ECE/TRANS/WP.29/GRPE/2007/6  
31 October 2006

**REVISED PROPOSAL FOR DRAFT AMENDMENTS TO REGULATION No. 110**

(Specific components for CNG)

Submitted by the expert from the European Natural Gas Vehicle Association (ENGVA)

**Fig. 1: 20 MPa Filling unit (receptacle) for M1 and N1 vehicles**

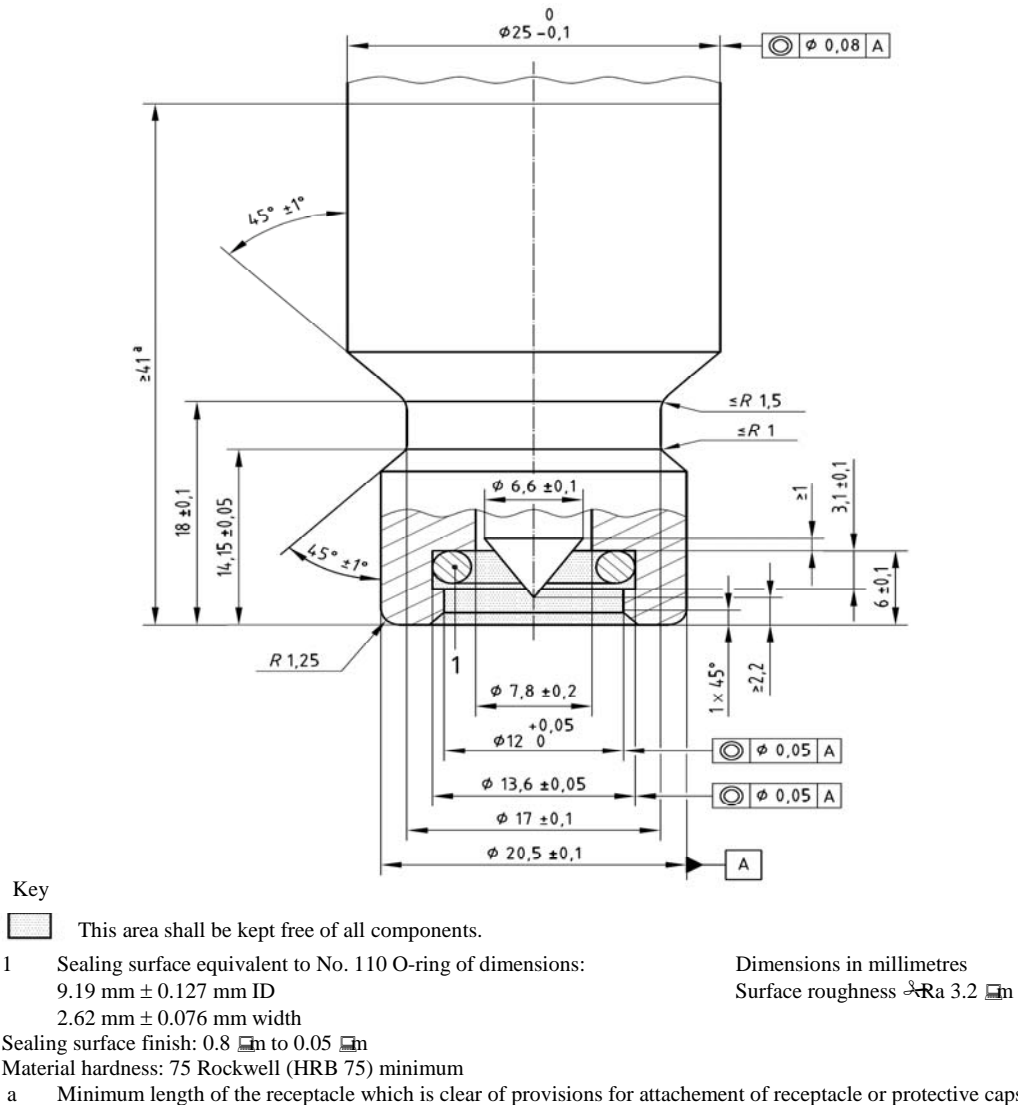
**"17.9.3. For vehicles of classes M1 and N1 the filling unit (receptacle) shall comply with the drawing specifications detailed in Figure 1 of Annex 4F.**

4.1. Figure 1 shows the dimensions of the filling unit for vehicles of categories M1 and N1. 2/
